REVISION 9/4/14 - PROFILE REVISION STATION 80+37.17 TO 87+51.38
- REMOVED LIME MODIFICATION OF EXISTING SOIL

FILE NAME 10/11/14	USER NAME KJS	DESIGNED -	REVISED KJS 9/4/14		HMG ENGINEERS, INC. ENGINEERS - SURVEYORS CARLYLE, ILLINOIS 62231 (618) 594-3711		CITY OF MOUNT VERNON 1100 MAIN STREET, P. O. BOX 1708 MT. VERNON, ILLINOIS 62864 (618) 242-5000	TYPICAL SECTIONS			F.A.U. RTE.	PROJECT	COUNTY	TOTAL SHEETS	SHEET NO.
PLOT SCALE 1"=40'	DRAWN -	REVISIONS -	VAR								VETERANS & 34TH TRAIL	JEFFERSON	41	4	
PLOT DATE 10/11/14	CHECKED -	REVISIONS -	SECTION					10-00133-00-BT	CONTRACT NO. 99534						
	DATE -	REVISIONS -	PROJECT					TE-0009401	HMC JOB NO. 7004

PROPOSED TYPICAL SECTION
VETERANS MEMORIAL DRIVE TRAIL
STA. 76+40.34 TO STA. 102+02.78

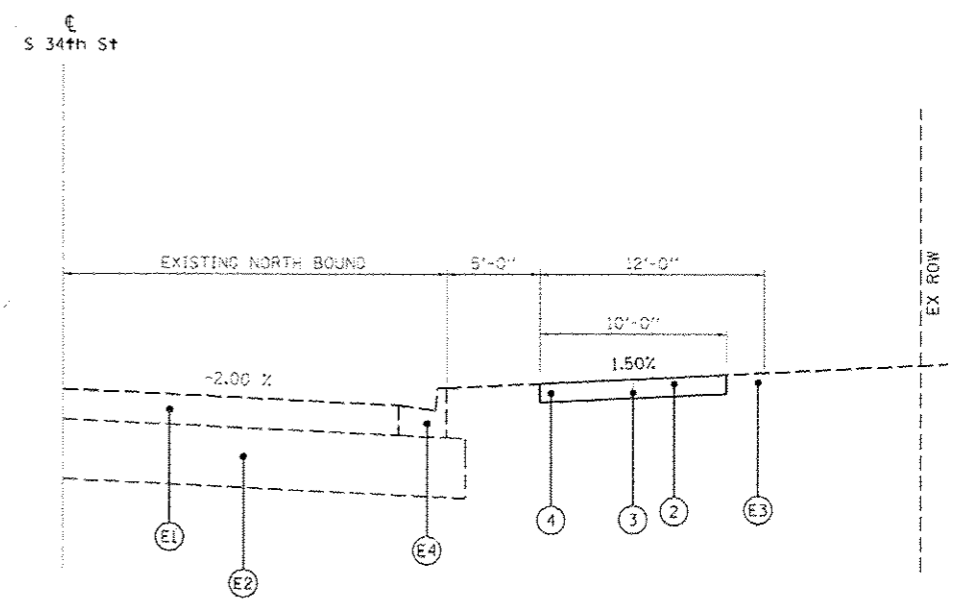
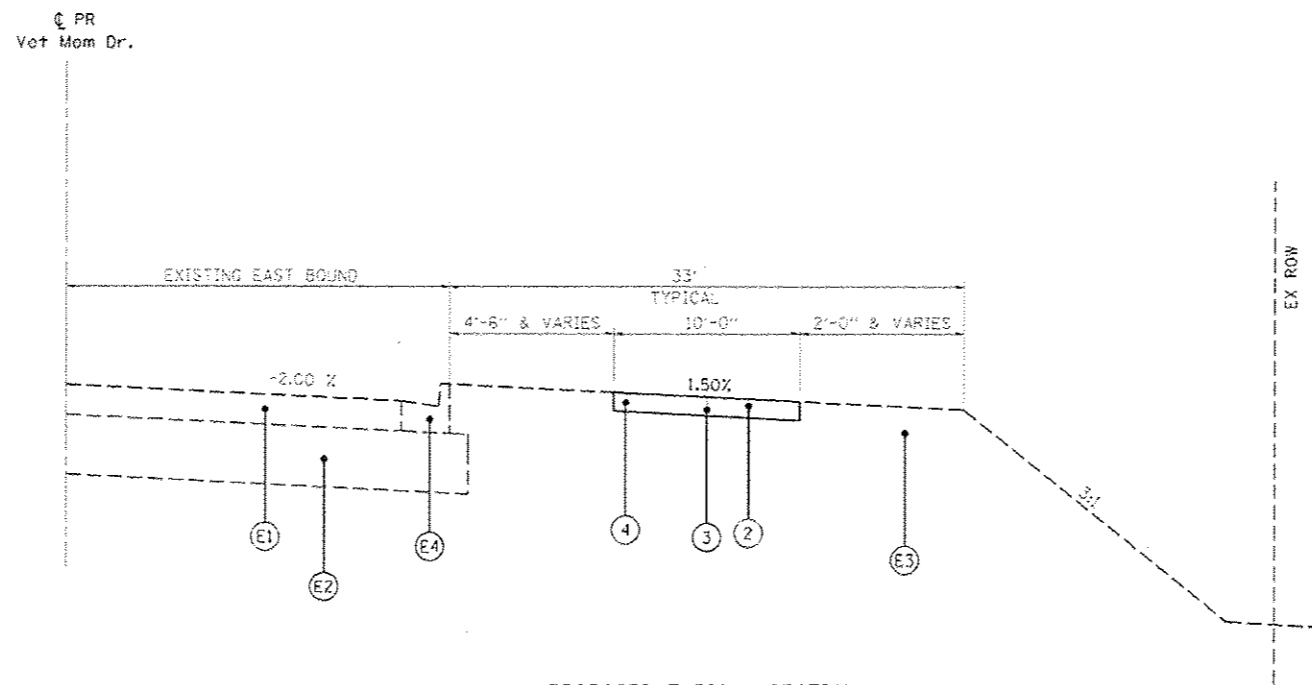
REVISION 9/4/14 - PROFILE REVISION STATION 80+37.17 TO 87+51.38
- REMOVED LIME MODIFICATION OF EXISTING SOIL
